# Eskew Dumez Ripple<sup>+</sup>

## **ADDENDUM NO. 1** 01/09/2026

**RE:** Odenheimer Phase 1  
EDR Project No. 22071

**FROM:** Eskew+Dumez+Ripple  
400 Lafayette Street, Suite 300  
New Orleans, Louisiana 70130  
(504) 561-8686

## 02 ROOF PLAN - DEMOLITION

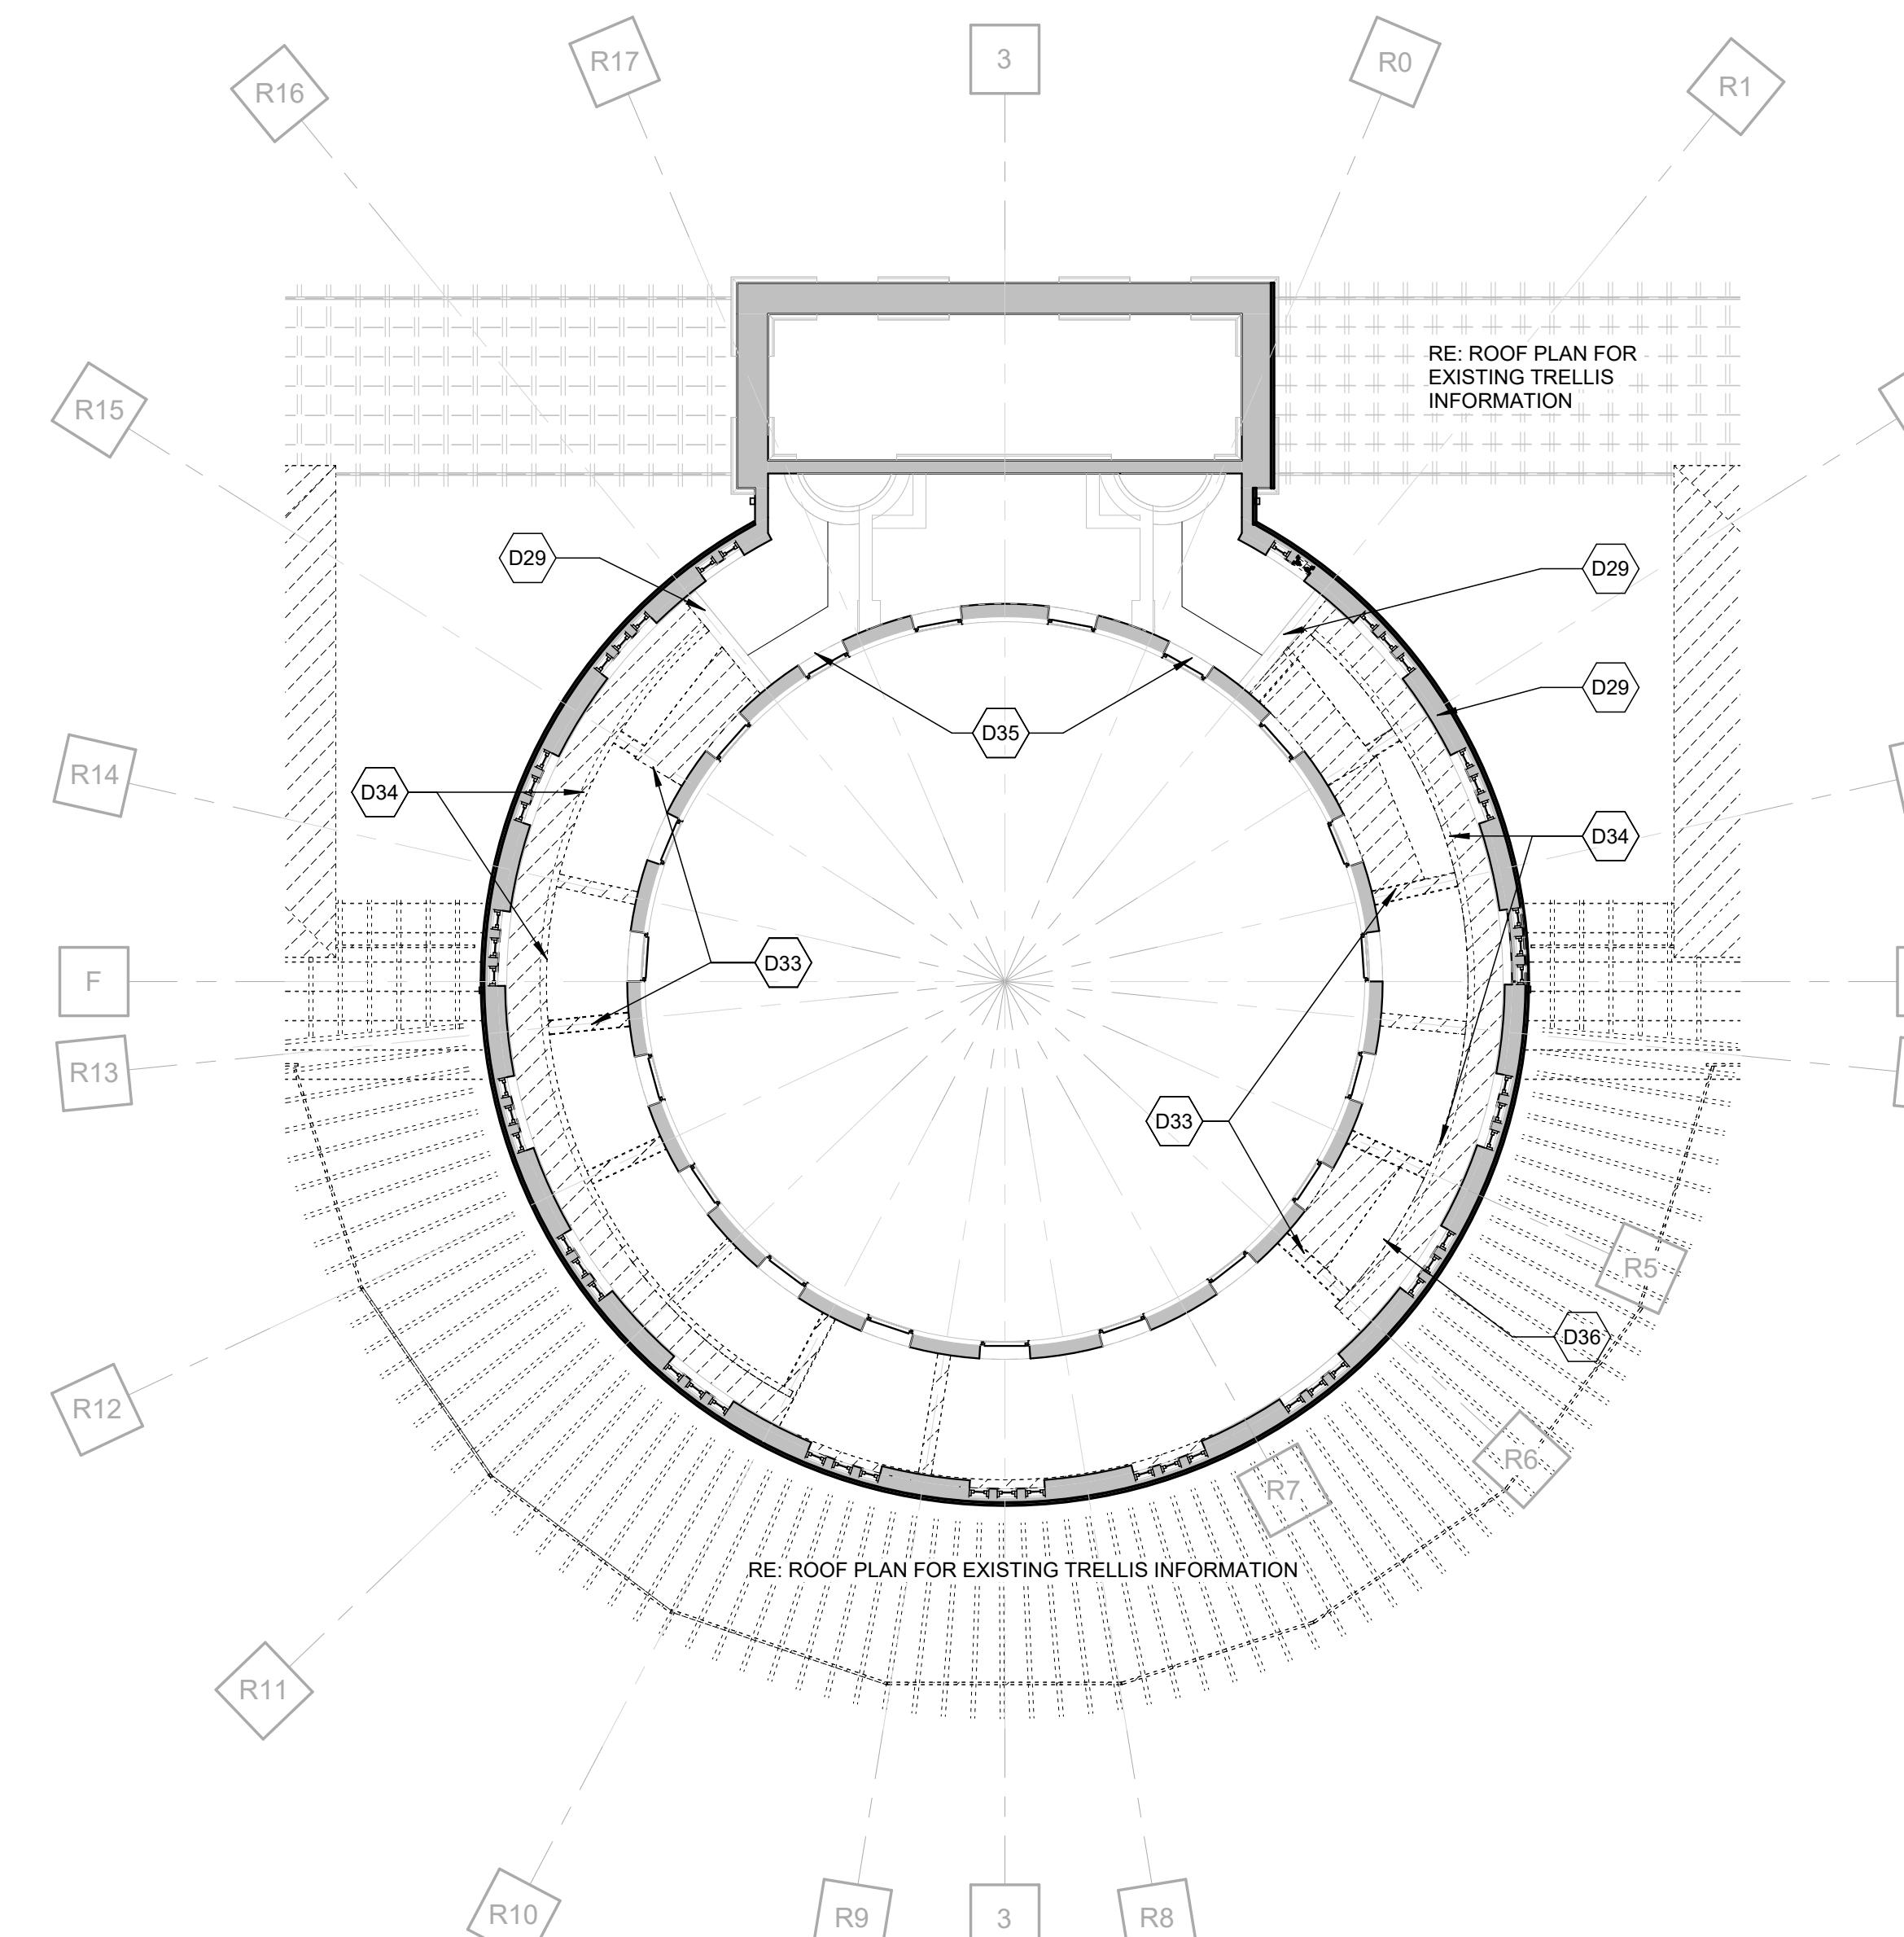
1. SHEET 1.22: Amend and clarify language at reptile house, included note E67
2. SHEET 1.41/Detail 02: Clarify gutter scope at reptile house wall intersecting with new Komodo exhibit.

## EXTERIOR ELEVATIONS - EXISTING PHOTOS

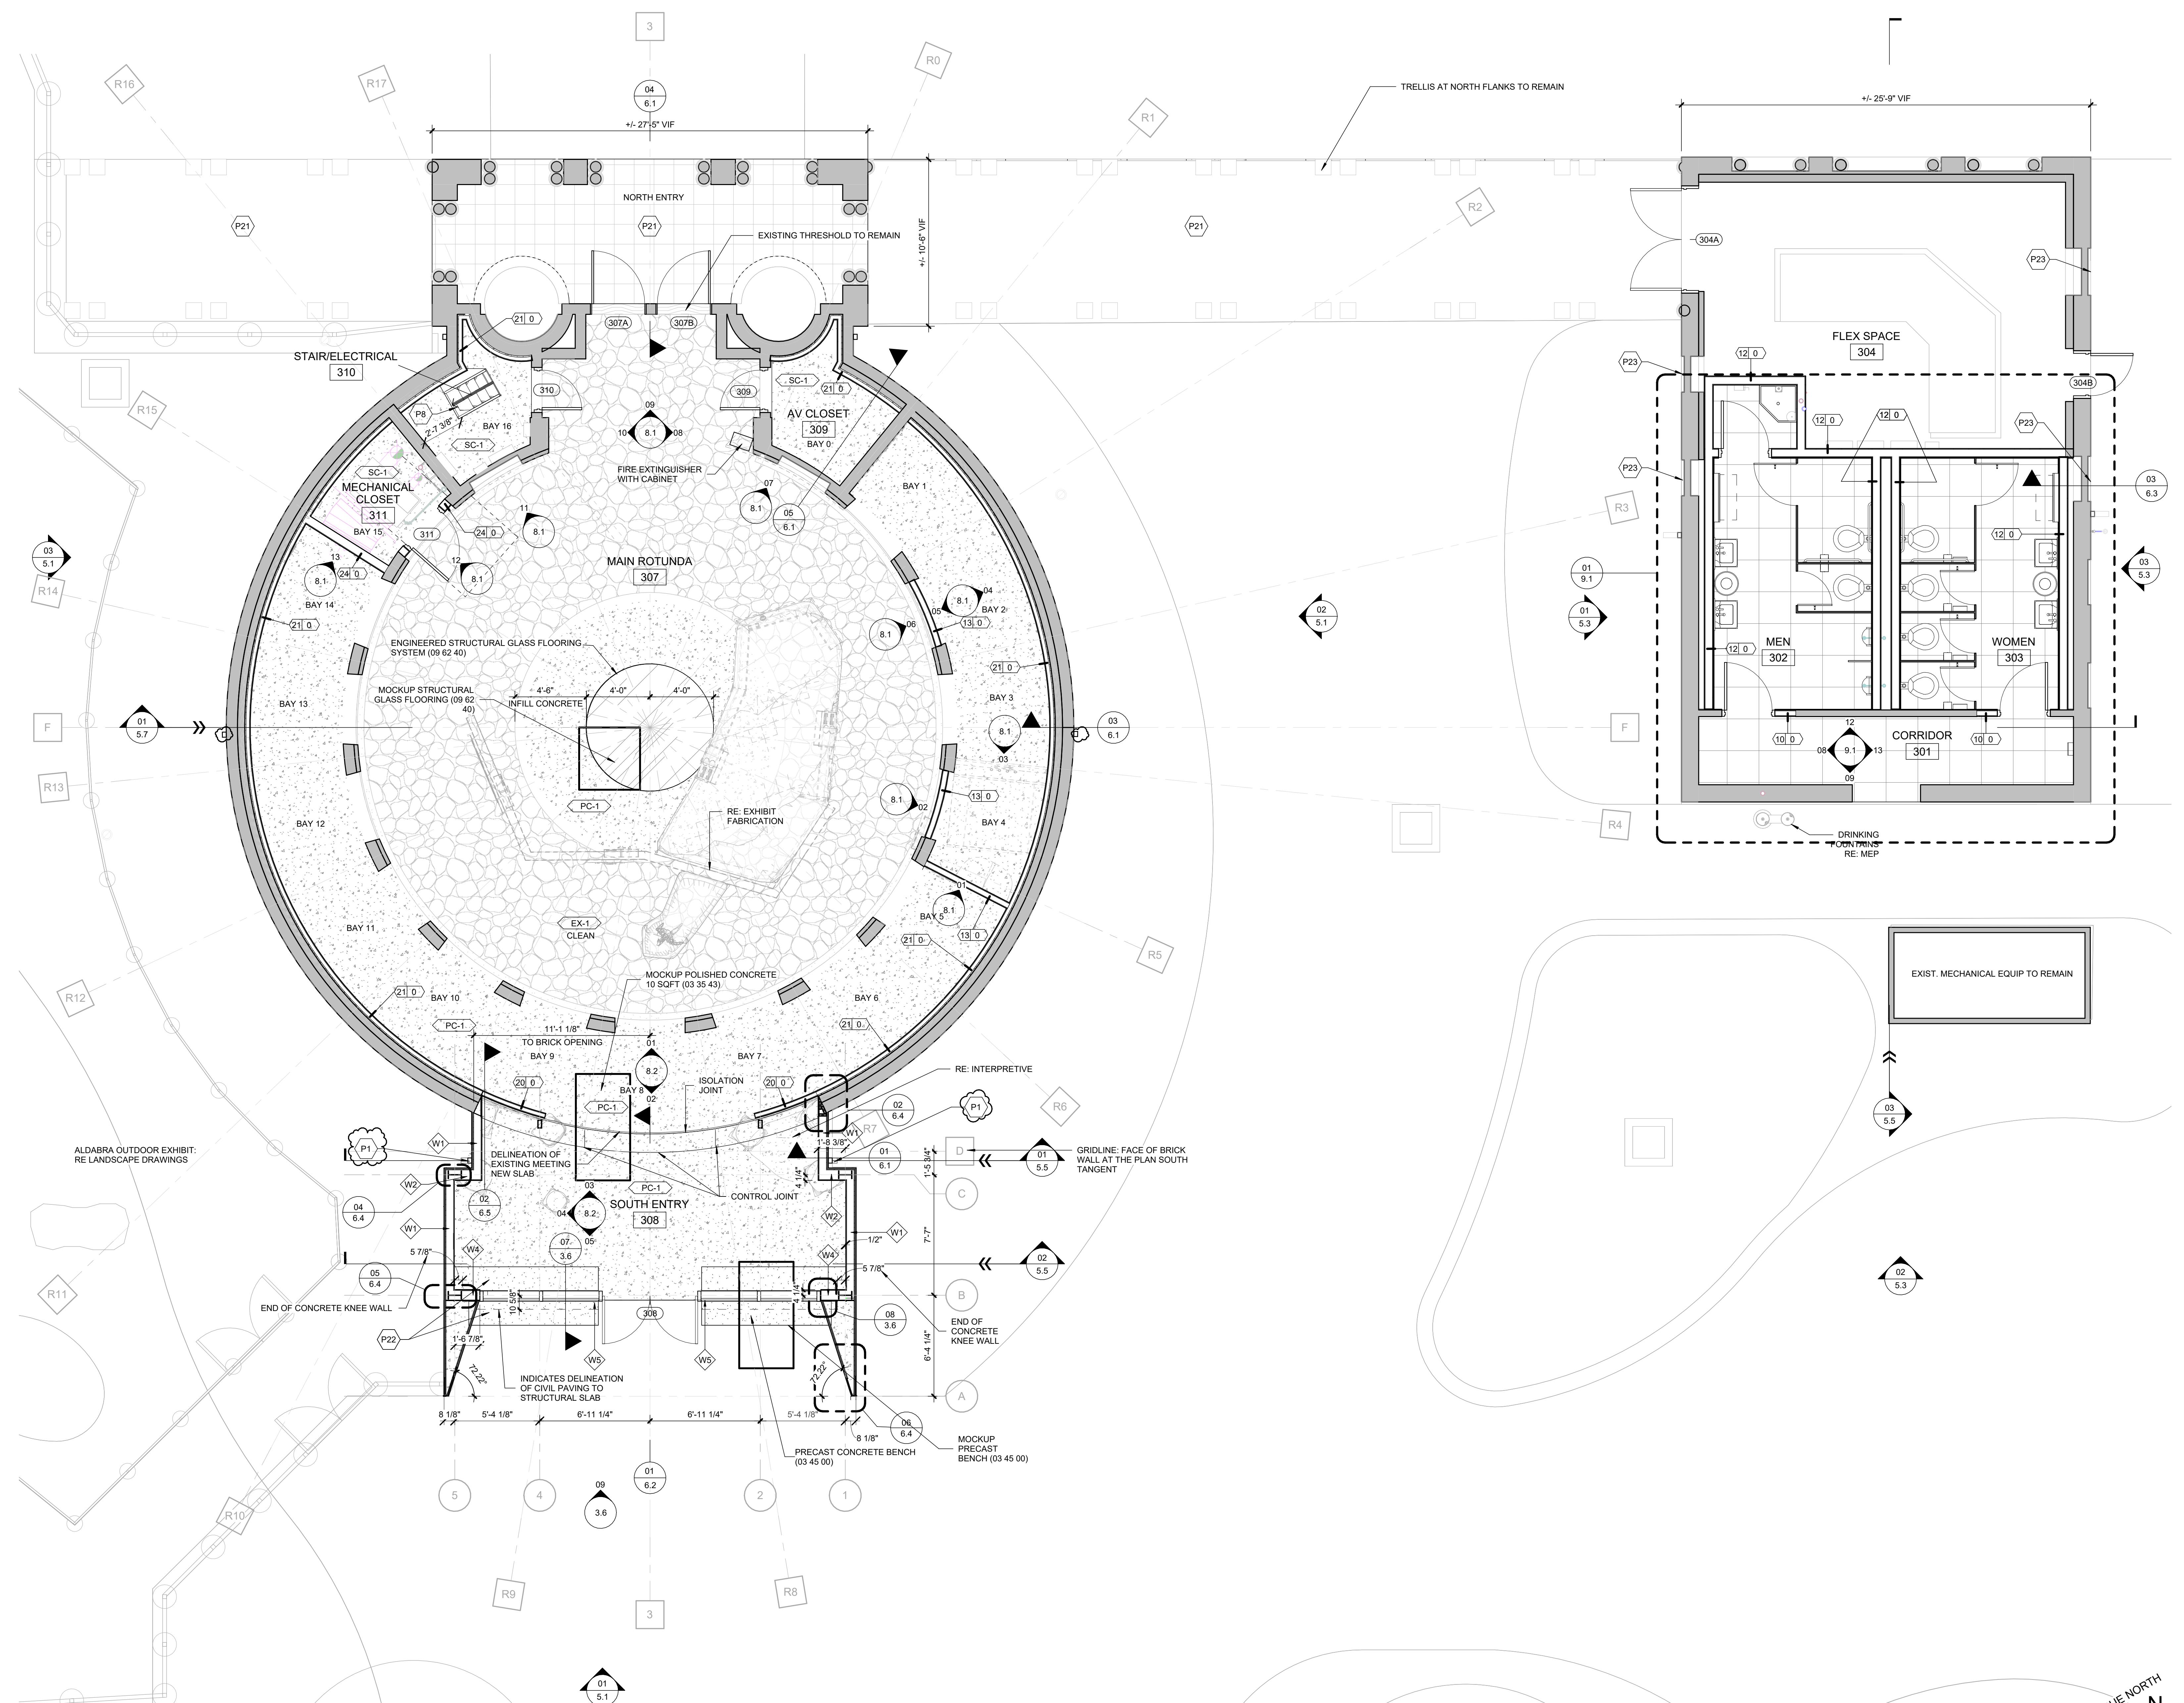
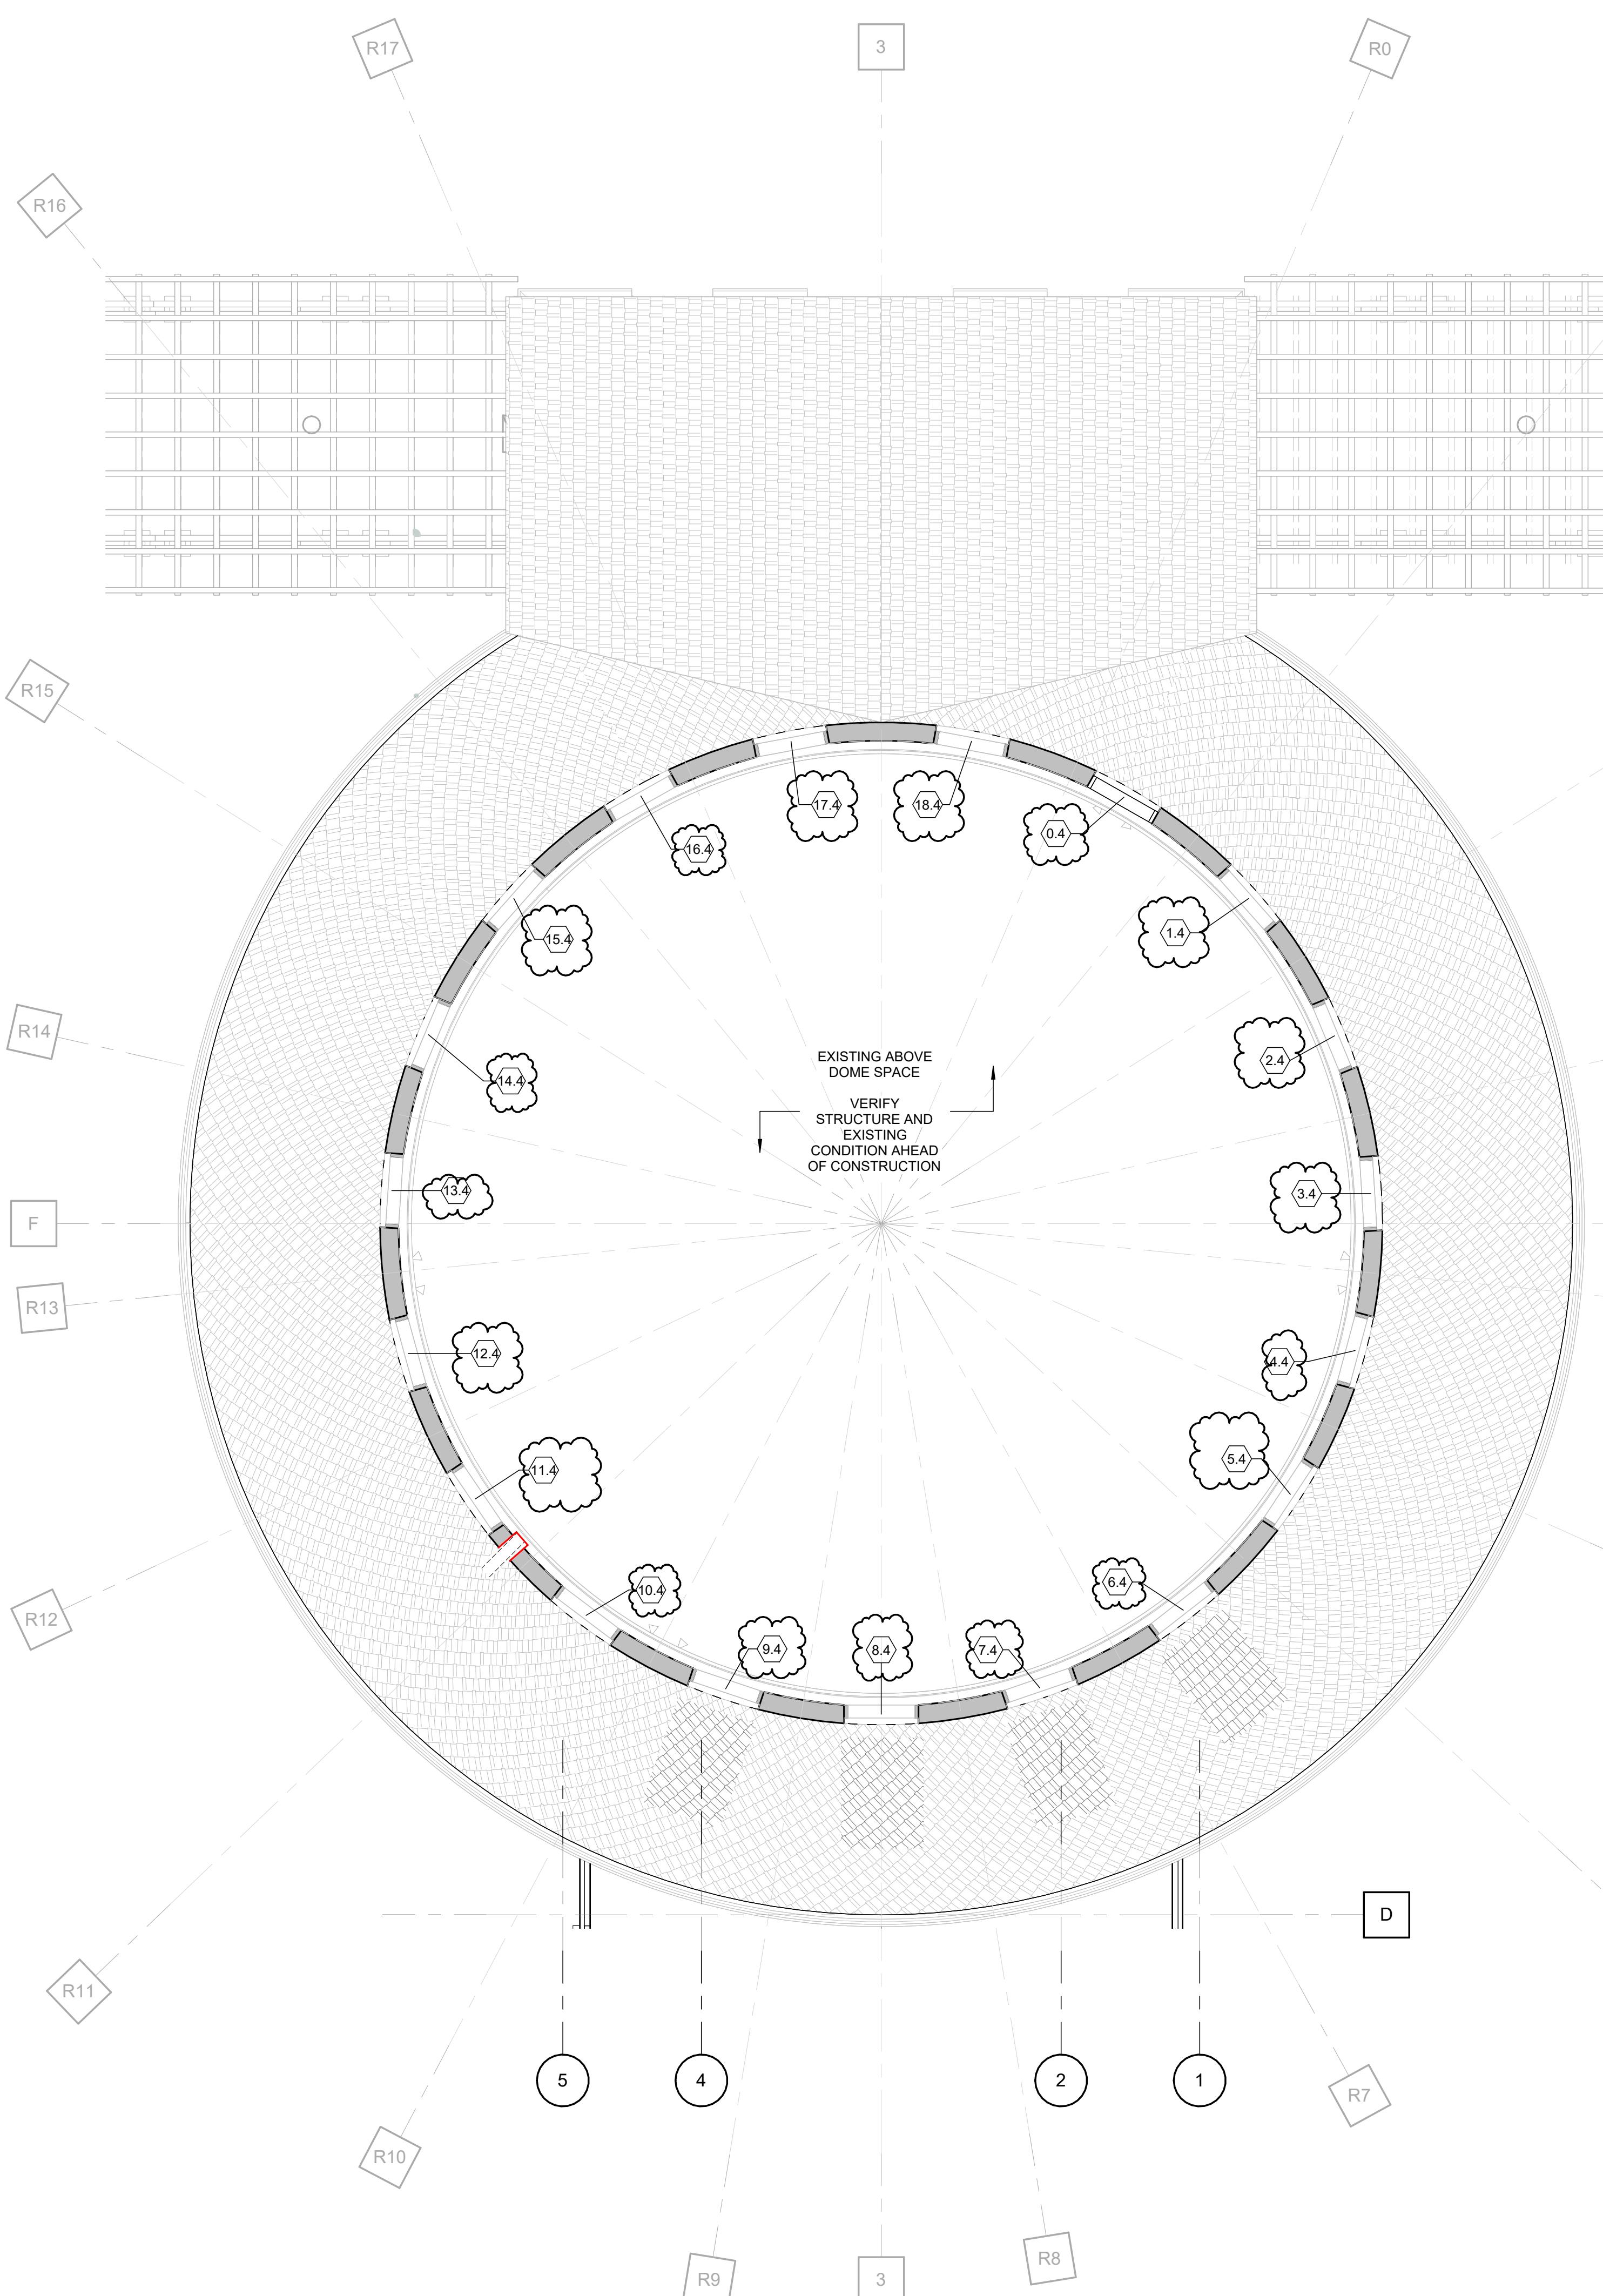
3. SHEET 1.52: Amend note E58 to describe plaster repair per information discussed with subcontractor and woodward. Include Notes E69 and E70 to clarify crack repair.

CLARIFICATION OF REFERENCE DESIGNATIONS	
E43	TRELLIS TO BE REMOVED EVERYWHERE EXCEPT NORTH LINEAR SECTION, SEE PLANS
E45	REPAIR AND CLEAN PLASTER AS REQUIRED
E48	REPAIR AND CLEAN BRICK AS REQUIRED
E49	CLEAN EXISTING PLASTER, TYP AT ROTUNDA AND FLANKING BUILDINGS.
E50	SAND, PRIME, AND PAINT EXISTING WOOD TRELLIS REMAINING
E51	CLEAN, REPOINT, AND REPAIR BRICK AS REQUIRED
E52	PROTECT EXISTING CORNICE TO REMAIN
E53	CLEAN EXISTING CAST STONE
E54	NEW SEALANT AT ALL EXISTING SEALANT JOINTS
E55	CLEAN EXISTING ROCKWORK
E57	SAND, PRIME, AND PAINT EXISTING WOOD
E58	AT EXISTING NORTH ENTRY PLASTER WALLS: CLEAN AND PATCH PLASTER, PROTECT EXISTING CORNICE, REINFORCEMENT, MATCH COLOR AND TEXTURE TO EXISTING A PLEASE EASING THE REPAIR CRACKS IN COLUMNS
E59	REPAIR CRACKS IN CORNICE AS REQUIRED
E60	REPAIR CRACKS IN COLUMNS
E69	REPAIR CRACKS IN CORNICE AS REQUIRED
E70	REPAIR CRACKS IN CORNICE AS REQUIRED
